| City of Parramatta | |

SECTION 4.15 ASSESSMENT REPORT Environmental Planning & Assessment Act 1979

| Subject Property: | Lot 43 DP 8884, 5 Mary Street, NORTHMEAD, NSW 2152 |
| Proposal: | Demolition of existing structures and construction of a two storey 90 place childcare centre with a basement carpark that has 24 car parking spaces. |

Figure 5: Site Plan. Source: Architectural plans prepared by Janssen Designs.

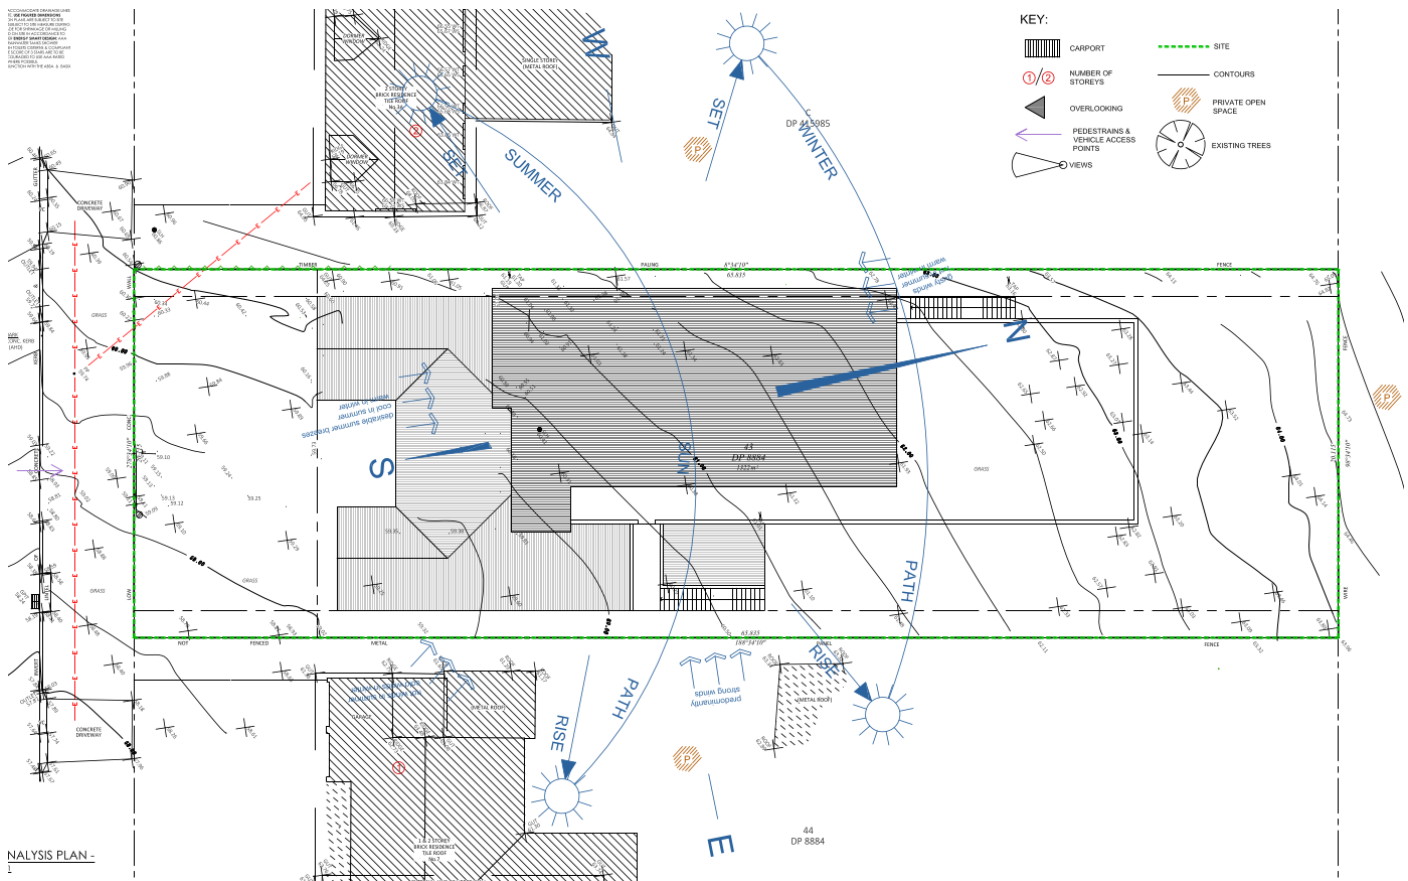
- (iii) *The Panel recommends further consideration be given to the design of the two front landscaped areas facing Mary Street. The Panel notes that fences and hedges are not currently proposed. If a defined edge is not desired, the landscape setting should be strengthened with appropriate planting to provide a more welcoming experience. The overall design should be integrated with the extended terrace suggested above.*
- (iv) *Given the residential character of the area, it is recommended that street CGI views are provided from either side to show how the built form is intended to relate with the neighbours.*
- (v) *Western boundary: consider extending the hedge planting along the western side of the site.*

Consider also amending the fire egress route to enable more substantial planting to occur.

- Refer to Items i) – iv) above for associated landscape improvements.
- Increase pockets of deep soil along the side boundaries to allow for increased numbers and coverage of larger canopy trees to screen and shade the outdoor play areas
- Explore the opportunity to increase planting to the upper outdoor play area and to increase the quantum of shaded areas.

(vii) Western elevation: Provide more articulation of the Western elevation particularly for the ‘box’ at the rear so that this long façade provides an improved interface with the neighbouring property. Additional tree planting along this boundary could also assist in softening the visual impact.

Planners comment: Council agrees with DEAP’s comment. A number of alterations can be made to improve the design regarding landscaping and pedestrian access.

Planners comment: Council agrees with DEAP’s comment. The building requires variation regarding both materials and built form to reduce bulk along the western elevation.

Figure 7: Streetscape (Mary Street) Elevation - Height. Source: Architectural plans prepared by Janssen Designs.

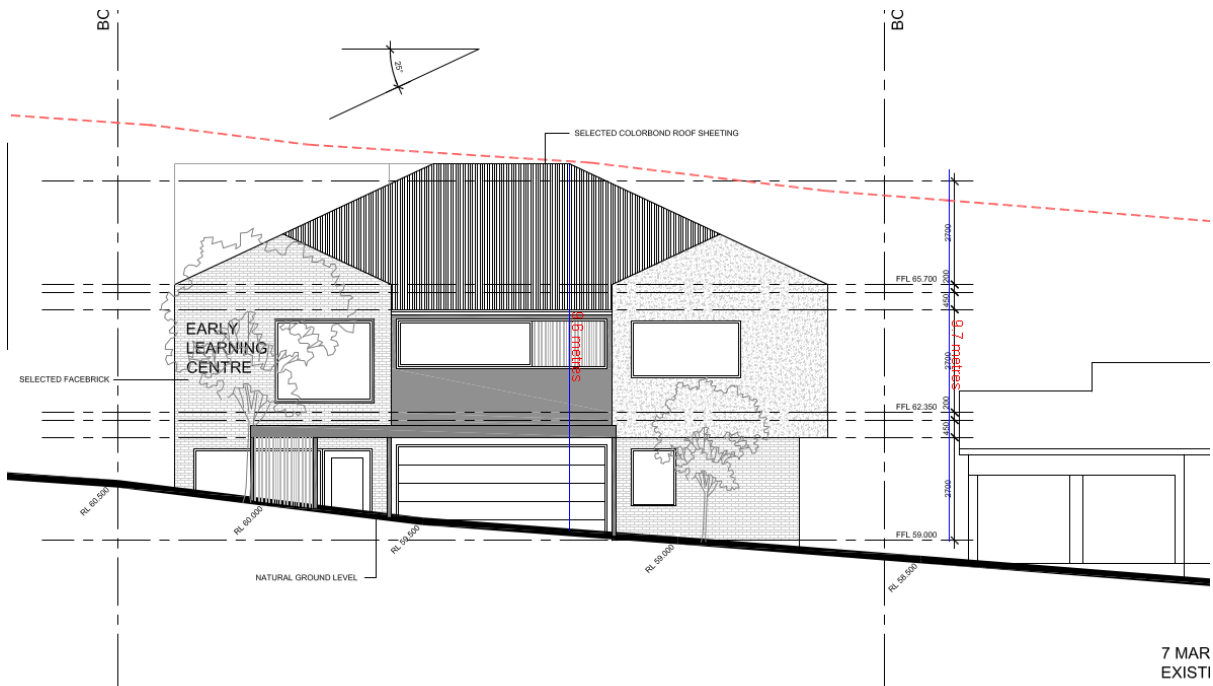
It is noted that a request for a written Clause 4.6 was not made considering the extent of changes required to ensure compliance with other matters as required. Council to date has not received a written request nor amended plans and as such, cannot provide development consent pursuant to clause 4.6.

The proposed development seeks the construction of a 90-place childcare within an R2 low density residential zone. In this regard, the clause serves to set a standard height plane across all developments within the zone.

The surrounding sites towards the East, South and West are all zoned R2 - Low Density Residential with R3 - Medium Density residential located to the North under the Parramatta LEP 2023. Under this plan there has been no change to the height development standard being 9m. In this regard, Council does not consider the zoning of the site to inhibit the objectives of the development standard.

- a. Clause 1.2 Aims of Plan
 - b. The proposed development exceeds the prescribed maximum height of building of 9 metres. No clause 4.6 objection has been lodged.
